APPLICATION

SEWAGE DISPOSAL TESTING

MARYLAND STATE DEPARTMENT OF HEALTH

PROPERTY OWNER W. R. Hall

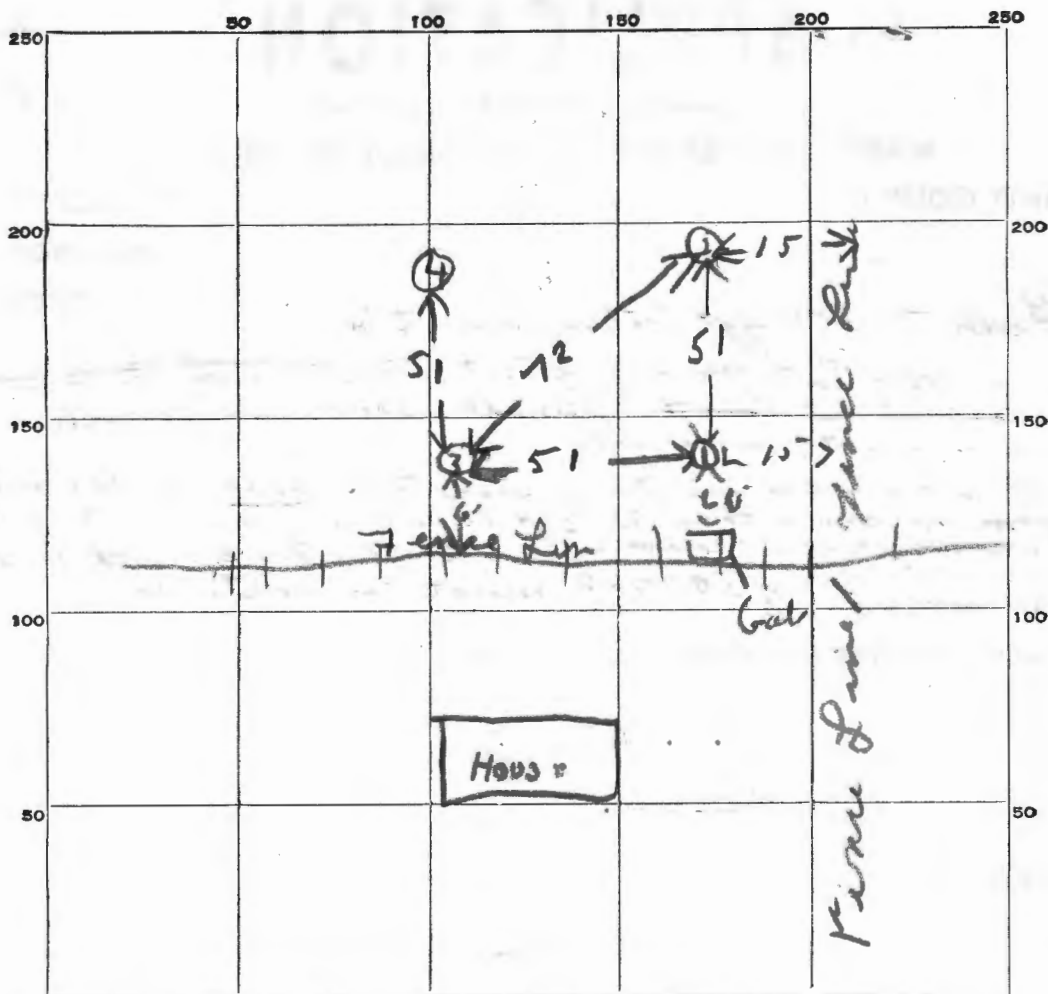
Tile Field - 300 sqft bottom area to be

located in area that passed perc test. First trench should run between connect test hole to trench. Trench should run parallel with fence line on right side of lot.

It is O.K. to use existing septic tank only if the outlet is not exceed no more than 2 1/2 ft below ground. If it is any more than 2 1/2 ft in the ground a new Septic Tank with a capacity of 500 gal must be installed

APPROVED BY Donald W. Monaghan FOR Tile Field DATE 8-29-62
(KIND OF SYSTEM)
